Notice of Advice

Attention	Amar Doshi	File No.	NoA-2_Final_v0
Company	Queensland Competition Authority	Date	02-Oct-2019
CC	chris.peart@qca.org.au	Total Page	14
Project Name	Engineering Assessment of Aurizon Network's FY17/18 Capital Expenditure Claim Review	Project No.	60591968_NoA-2
AECOM Ref	60591968_Var#2	Client Ref	1387050_Ref#4190
From	Susheel Prabhakar		
Service	Review of Aurizon Network's Submission to QCA's Draft Decision		
Email	amar.doshi@qca.org.au

1.0 IV.00154 FY17 Autotransformer Renewal Project

Figure 1 Proposed Bund Wall Replacement Earthing

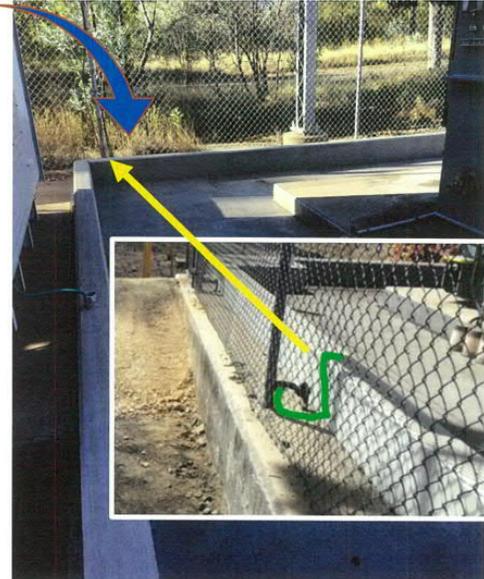
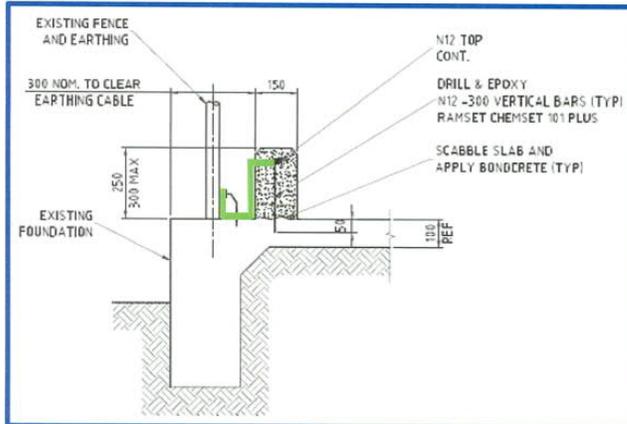
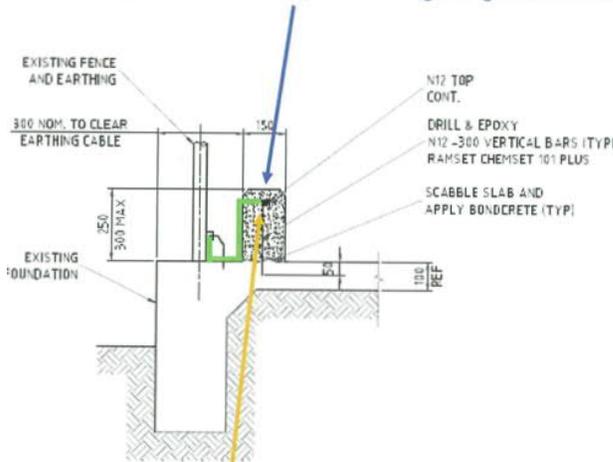
- a) No new information was provided by Aurizon Network in its submission to the QCA in response to the Assessment Report in relation to the lack of design drawings for the connection of the bund to the earth grid.
- b) In response to QCA's draft decision, Aurizon Network did not satisfy the first request of providing electrical RPEQ drawings of the bund wall earth bonding, however, provided new information showing details of a proposal to retro-fit a new bonding cable to connect the bund wall reinforcement to the existing earth grid at each site as described in Figure 1.

Electrical RPEQ signed off drawings for each site, showing the modification to the earth grid, following the new bund installations, and the connection of the rebar into the earth grid have not been sighted. However, in response to QCA's draft decision, new information showing details of a proposal to retrofit a new bonding cable to connect the bund wall reinforcement to the existing earth grid at each site was provided by Aurizon Network. This proposal, as described in Figure 1, is considered acceptable, as the likelihood of injury to personnel (between now and the time of the rectification) from touch potential is very low and therefore satisfies requirements of AS2067:2016. Aurizon Network in response to QCA draft decision state, that, '*Aurizon Network intends to complete the connection of the steel reinforcing within the new oil containment bunds to the existing earth grid (estimated at \$10k per site) in a future year and intend to include these associate costs within a future Capex Claim. Aurizon Network will include the earthing for all future renewal sites into the forward-looking autotransformer renewal program'*. We consider this additional cost to retro-fit as not being efficient because the cost for this task, if it was done as part of the upgrade activities, would have been minimal.

Aurizon Network proposal to retro-fit a new bonding cable to connect the bund wall reinforcement to the existing earth grid at each site already upgraded, as soon as is practically possible, and commitment to include this task as part of future Autotransformer site upgrades satisfies requirements of AS2067:2016. However, the review team believes that the extra costs which will be incurred in future years estimated by Aurizon Network to be in the order of \$10,000 per site to retro-fit the already upgraded sites, is not efficient on the basis that costs to undertake this task as part of the planned site upgrades would have been minimal.

For the purposes of FY17/18 capital expenditure claim, this matter is considered resolved and the bonding to earth grid arrangements is therefore, considered prudent and efficient.

Figure 2 Excerpts of Typical Drawings Showing Earth Grid Suitability for Outward Opening Gates

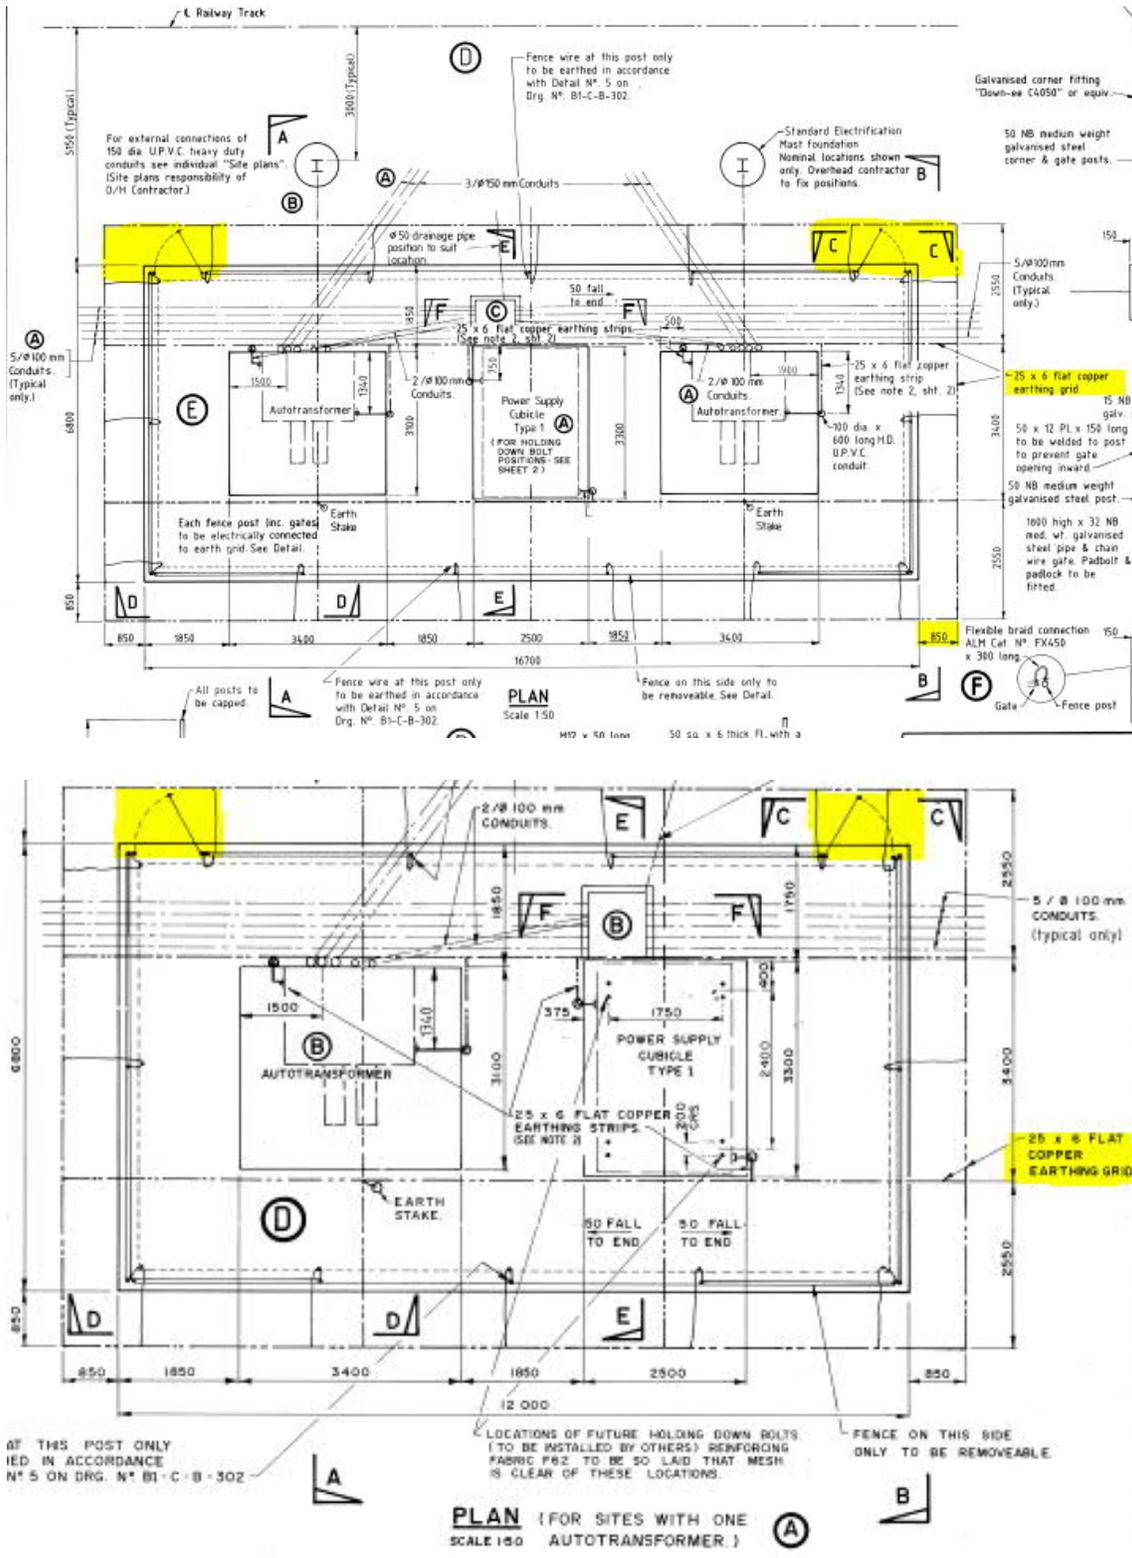
Additionally, photographs sited showed that after the upgrade, the gates at these sites open outwards which would mean that the earth grid should have been extended to ensure that there are no excessive step and touch potentials when the gate is in the open position. No design drawings were made available until the meeting held on 26 September 2019, where Aurizon Network explained that original earth grid design incorporated requirements for outward opening gates even though the gates were installed to open inwards. Due to the installation of the bund-walls it was no longer possible to have the gates open inwards due to space constraints and the gates are now installed to open outwards. This however, did not need any modifications to the earth grid as the original earth grid was installed to cater for outward opening gates in the first place as shown in Figure 2.

After review of this information we conclude that step and touch potential issues due to outward opening gates is not material if the earth grid was in-fact installed to cater for outward opening gates during original construction as stated by Aurizon Network and shown on the design drawings and therefore the earth grid is in accordance with AS2067:2016.

Figure 3 Balook Autotransformer Site

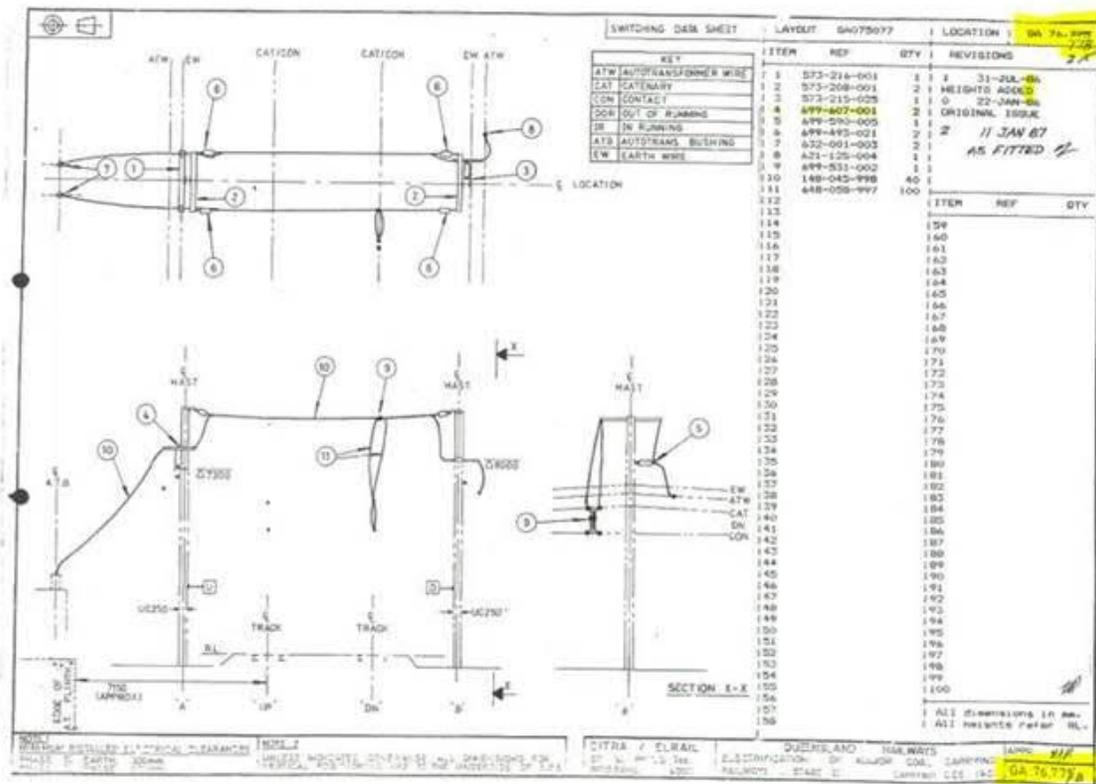
In response to QCA's draft decision, Aurizon Network provided new information in the form of typical photos and site-specific as-built drawings showing that surge arrestors have been installed at each site as claimed in their 2019 Autotransformer site-specific risk assessments as an existing control to minimise risk exposure at the three sites, namely, Balook (Figure 3), Epala/Ambrose (Figure 4) and Dingo (Figure 5).

We note that while Balook and Epala/Ambrose sites have surge diverters only, Dingo site has both the surge diverter and lightning rod. Surge divertors and lightning rods serve different purposes. During the recent clarification meeting of 26 September 2019, Aurizon Network advised that the decision of not installing lightning rods at Balook and Epala/Ambrose sites would have been based on risk assessment undertaken at the time of original studies, design and construction of those sites. These risk assessments are not available now. On the basis of Aurizon Network's clarification and the presence of adjacent OHLE masts at these sites, the review team is satisfied that separate lightning rods at Balook and Epala/Ambrose sites would likely not be required. However, we recommend that lightning risk assessments be undertaken in accordance with AS1768:2007 for future AT site upgrades.

Surge protection system are considered prudent and efficient. However, we recommend that lightning risk assessments be undertaken in accordance with AS1768:2007 for future Autotransformer site upgrades.
